BIDDING ADDENDUM 3

For work titled:
Acee's Neighborhood Market & Deli
1000 Holiday Lane
Fulton, KY 42041
Project Number: 23-7038

Tile Wall To Concrete Floor Base Detail

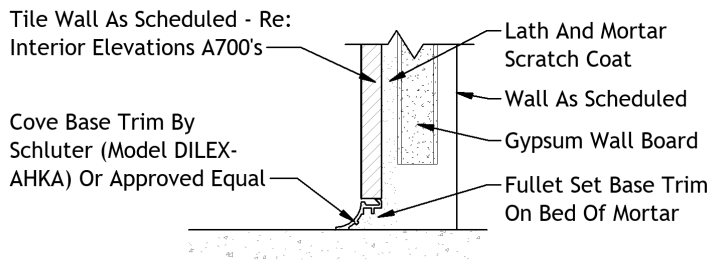
2. Sheet A702	REVISE A702 detail #6 shows a 6" rubber base at the base of the wall tile. This is not correct. It should be as shown on the attached document "Tile Wall to Concrete Floor Base Detail" CLARIFICATION A702 detail #7 – Does the wall tile extend to the adjacent wall? (south wall next to Vestibule 3 #122). See attached Restroom Wall Tile diagram for clarification.
3. Sheet C301	ADD the following note #6 to the site utility plan notes: Conduit Routing Notes: do not cross fuel dispensers classified boundary locations (e.g. 20.0' from dispensers being Class1/Division2) with other conduits not associated with fueling system. Any conduits that cannot avoid passing through these areas shall be RGS (rigid galvanized steel) and installed with seal-offs when

10.	QUESTION What type of base will be used for Alternate 1? The base for the alternate (if using tile flooring) should be BT2 and metal cove base, detail 4/A701 would apply.
11.	CLARIFICATION Walls in the following rooms 107, 112, 113, and 117 shall be P1 paint (floor to ceiling) and B1 base.
12.	CLARIFICATION Where tiled walls are in rooms with concrete floors we have provided a detailed for clarification - see attached "Tile Wall to Concrete Floor Base Detail"

— W2 To 4'-6" AFF & W1 4'-6" To 10'-0" AFF

— W2 To 4'-6" AFF, TR1 Transition To P5

— W2 To 4'-6" AFF & W1 To Partial Wall Extent

— W3 To 10'-0" AFF

All walls shall be P1 Floor To Ceiling With B1:

- Storage 117
- Electrical & Fuel Controls 113
- Porter Laundry & Storage 112
- Office 107

LOW-VOLTAGE DISPENSER DISCONNECT: (one for each fuel island)

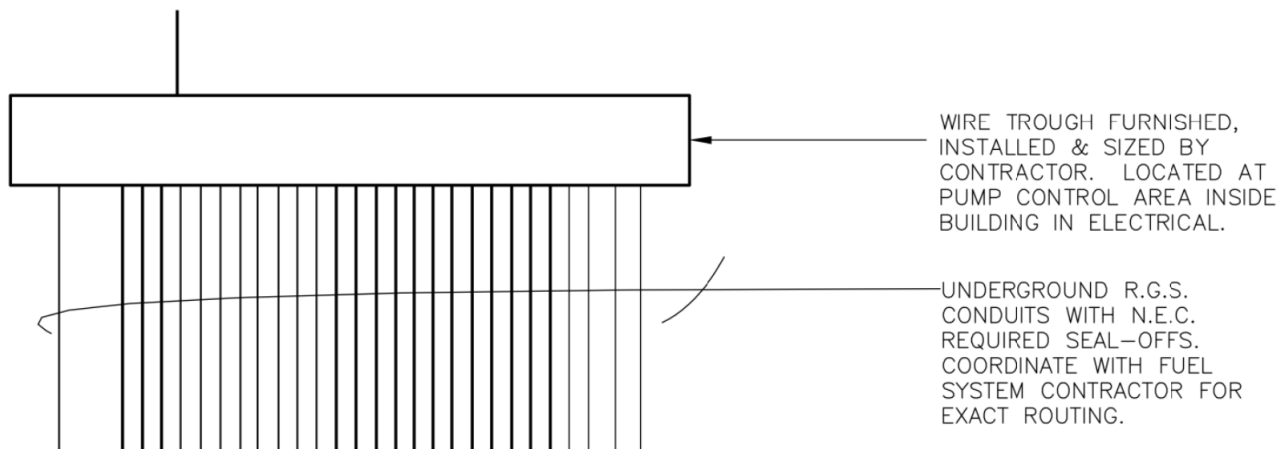
4. Sheet C601	<p>ADD to detail 1/C601 the note: "For Informational Purposes only: the 22,000 gallon fuel tanks are estimated to weigh between 19,000 and 22,000lbs; the contractor shall verify this with the fuel supplier to be sure they have the necessary equipment on site to offload and set the tanks"</p> <p>ADD to detail 1/C601 the note: "The owner is responsible for hiring a 3rd party to perform a tank tightness test on the fuel tanks per KYOSFM regulations. The contractor is responsible for ballasting the fuel tanks with WATER and the DEF tank with DEF on the day of installation. The owner will arrange and pay for the delivery and cost of DEF. The contractor is responsible for getting all water completely pumped out of the fuel tanks prior to them being filled with fuel".</p> <p>MODIFY detail 1/C601 t note the center tank to be a 22,000 gallon diesel tank and the tank on the right to be split 22,000 gallon tank with 6,000gal premium and 16,000 gallon gasoline.</p> <p>ADD the attached "Fuel System Electrical Notes".</p>

CONTRACTOR SHALL FURNISH AND INSTALL A DISCONNECT FOR ALL LOW-VOLTAGE CABLES/WIRES SERVING FUEL DISPENSERS PER NEC 514. DISCONNECT SHALL BE EQUAL TO SQUARE D #LVDD-V-8S AND SHALL BE CAPABLE OF ACCOMMODATING UP TO EIGHT (8) FUEL DISPENSERS CABLING. LOCATE UNIT AT PUMP CONTROL AREA IN ELECTRICAL ROOM. FURNISH ALL HARDWARE, CONDUIT AND WIRE TO MAKE THIS SYSTEM FULLY OPERATIONAL.

EXTERIOR LIGHTING TIME CLOCK DETAIL AND SCHEMATIC DIAGRAM - 2 CHANNEL

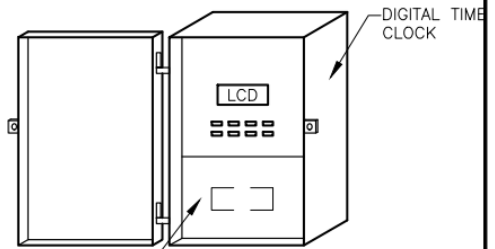
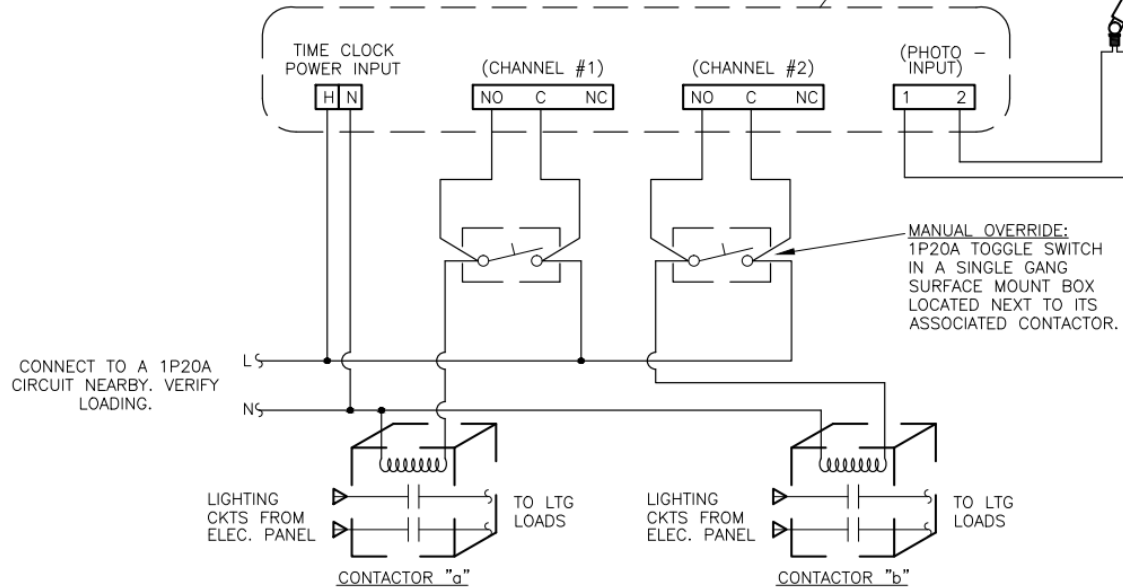
8. Sheet E301	ADD the attached detail "Exterior Lighting Time Clock Detail & Schematic Diagram – 2 Channel"
9. Sheet M101	<p>ADD note #8 to the General HVAC Notes: Entire HVAC system shall be balanced by a certified test and balance contractor. All air flow rates shall be within 5% of the specified flow rate. Provide certified test and balance report at end of project.</p> <p>ADD note #9 to the General HVAC Notes: Seismically restrain HVAC equipment, gas piping and hydronic piping as required by State, Local and National Codes. Provide support equipment required to control expansion and contracting of piping, provide loops, pipe offsets, and swing joints or expansion joints were required.</p>

TIME CLOCK: 2-CHANNEL DIGITAL TIME CLOCK EQUAL TO TORK #DGLC SERIES.

PHOTOCELL: TORK #EPC1

CONTACTORS: ELECTRICALLY HELD MULTIPOLE CONTACTORS EQUAL TO SQUARE D 8903 LG SERIES.

OPERATION: CHANNEL #1 (CONTACTOR "a") SHALL BE PHOTO ON/TIMED OFF
----- (EXTERIOR AREA LIGHTING) -----

CHANNEL #2 (CONTACTOR "b") SHALL BE PHOTO ON/PHOTO OFF
----- (EXTERIOR BUILDING LIGHTING) -----

1. SEE LIGHTING PLANS TO DETERMINE WHICH CONTACTORS ARE REQUIRED AND HOW MANY POLES ARE NEEDED. ALLOW FOR TWO SPARE POLES ON EACH CONTACTOR.
2. COORDINATE PHOTOCELL MOUNTING TO AVOID PICKING UP ARTIFICIAL LIGHTING SOURCES.
3. CONTACTORS SHALL BE MOUNTED ADJACENT TO PANELBOARD WHERE LIGHTING LOADS ORIGINATE.
4. CONTRACTOR SHALL BE RESPONSIBLE FOR PROGRAMMING TIME CLOCK AND PROVIDING TRAINING TO OWNER.
